Outer Appearance Change of the General-Purpose Inverter Option FR-BFP2

FR-BFP2 series

Screw size for inverter rear panel installation (before)

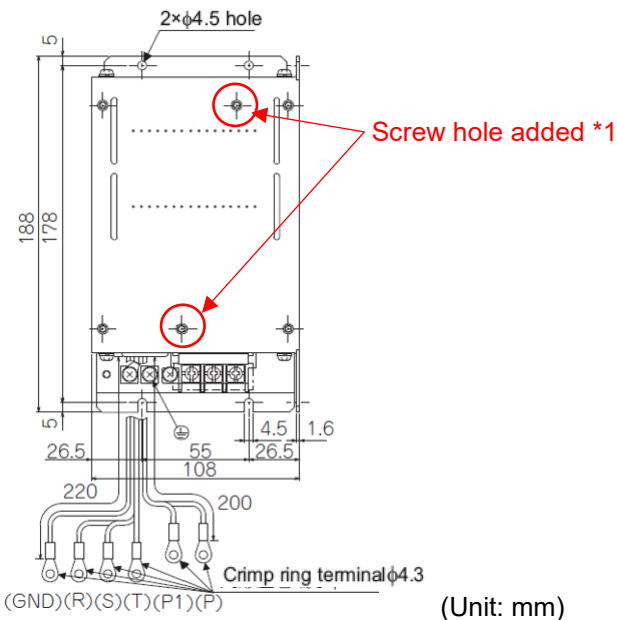
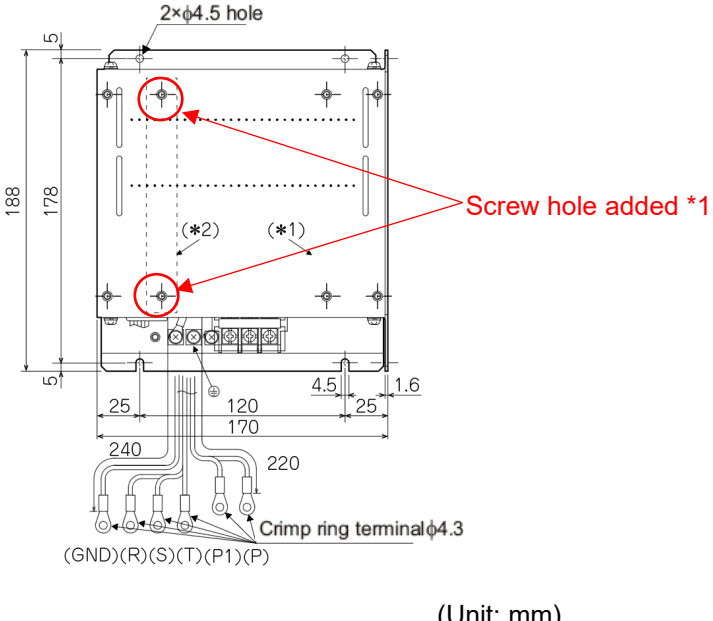
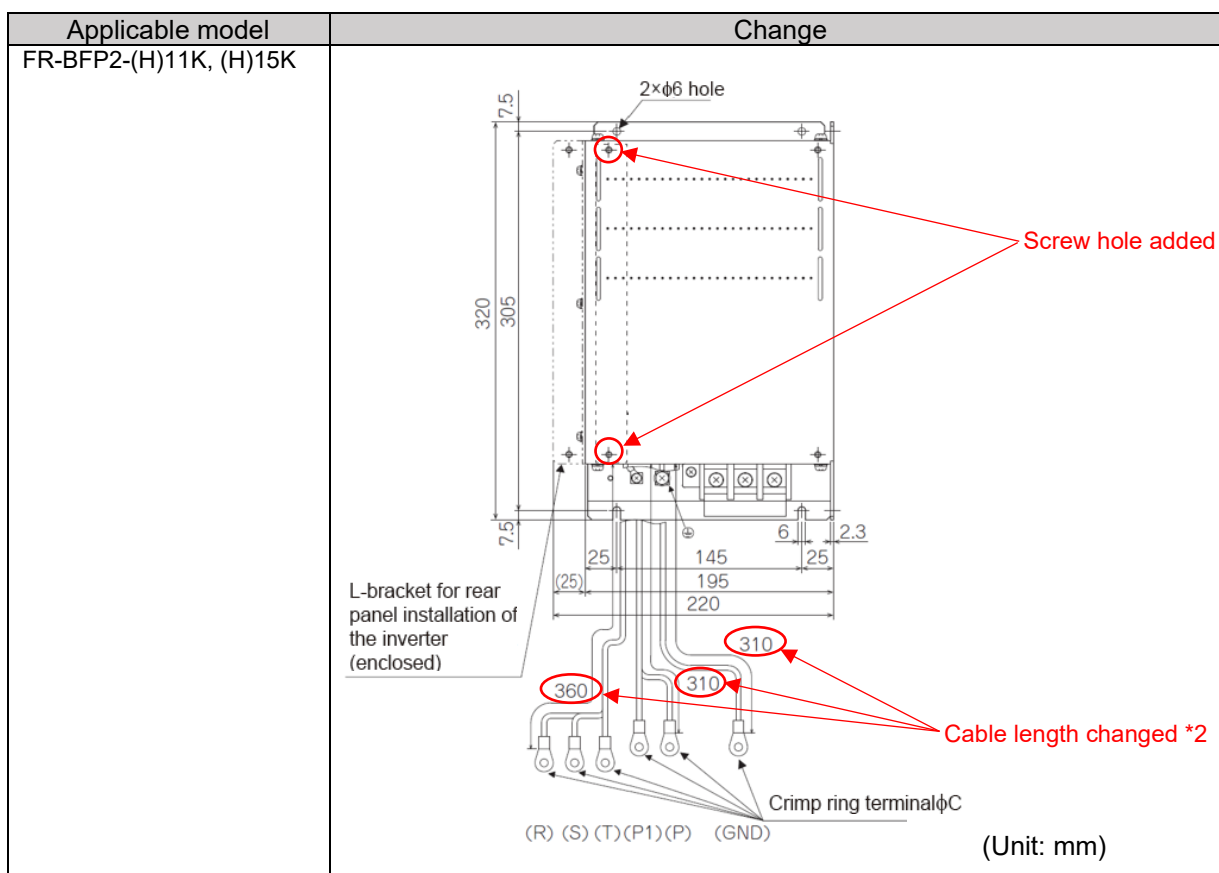
- 1) The size of the enclosed screws for inverter rear panel installation will be changed as follows to improve workability. Along with the screw size change, the appearance will be changed.
The change does not affect the quality, performance, or specifications of the products.

Before
M4 × 14

After
M4 × 16
